DUNCAN CORNER ADDITION

RE: S/D 99-35 - One-Step Final Plat of Duncan Corner Addition

RE: S/D 99-35 – One-Step Final Plat of Duncan Corner Addition

CASE NUMBER: S/D 99-35 - DUNCAN CORNER ADDITION

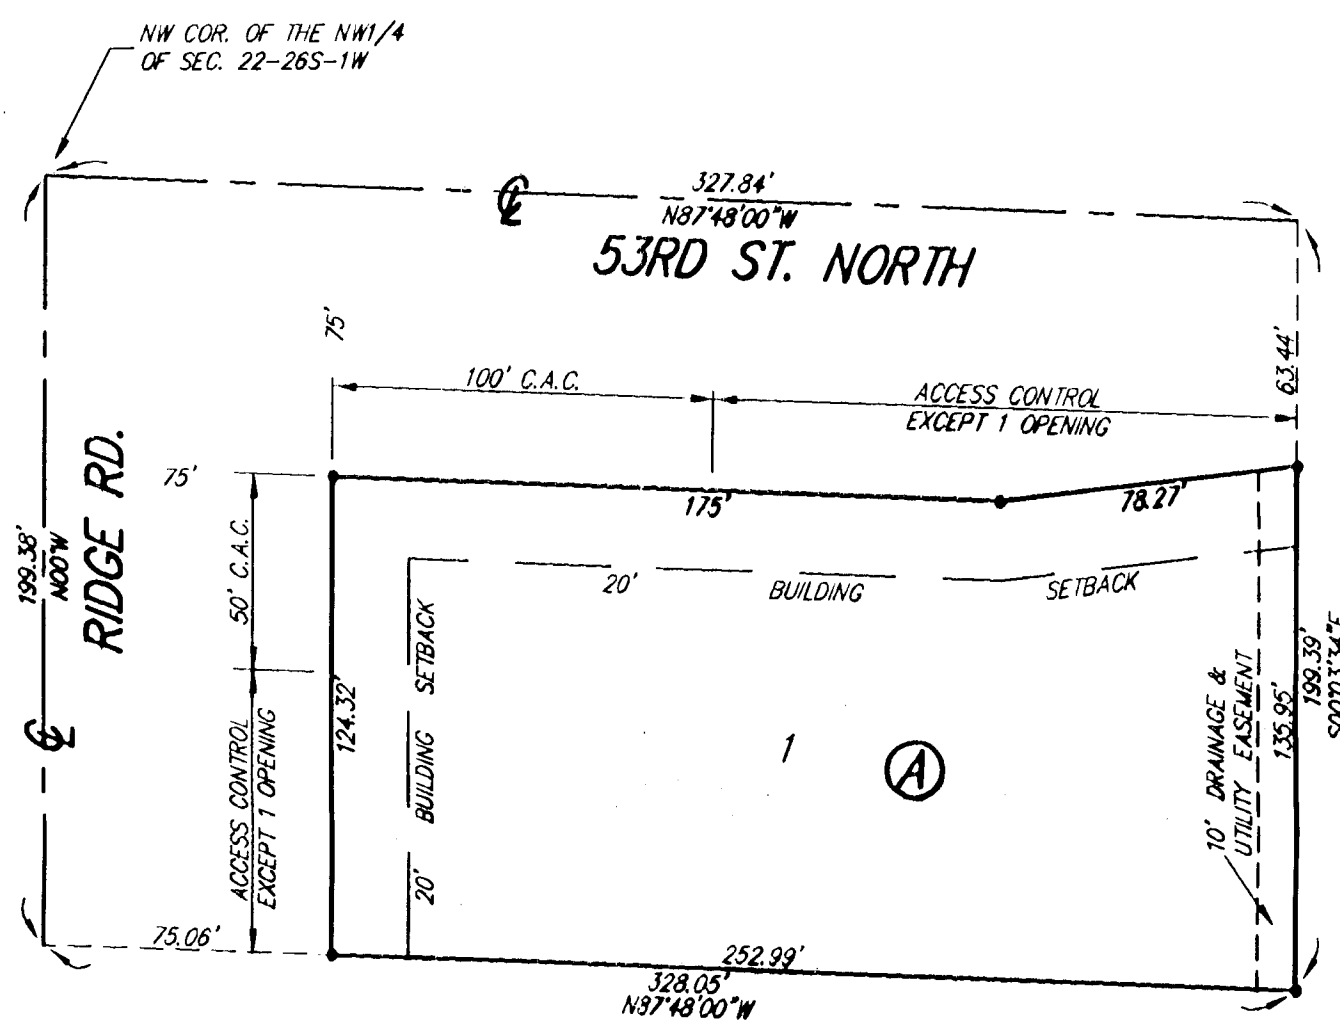
- C. County Engineering needs to comment on the status of the applicant's drainage plan. ***The drainage plan is approved.***
- D. County Engineering needs to comment on the access controls. The plat proposes two access openings along 53rd St. North and one access opening along Ridge Road. The plat also denotes 50 feet of complete access control along both perimeter streets from the intersection; although the Subdivision regulations require 150 feet of complete access control for 53rd St. North. ***100 feet of complete access control shall be required along 53rd St. North from the intersection. One access opening along both streets is permitted.***

- E. The Applicant shall guarantee the closure of any driveway openings being located in areas of complete access control or that exceed the number of allowed openings. *The applicant shall reconstruct the driveway at the time of site development.*

- G. To allow for County Commission approval, the County Commissioners signature block needs to be added. Bill Hancock is the only signature required.
- H. This property is within a zone identified by the City Engineers' office as likely to have groundwater at some or all times within 10 feet of the ground surface elevation. Building with specially engineered foundations or with the lowest floor opening above groundwater is recommended, and owners seeking building permits on this property will be similarly advised. More detailed information on recorded groundwater elevations in the vicinity of this property is available in the City Engineers' office.

- I. The platting text shall include language that a drainage plan has been developed for the plat and that all drainage easements, rights-of-way, or reserves shall remain at established grades or as modified with the approval of the applicable City or County Engineer, and unobstructed to allow for the conveyance of stormwater.
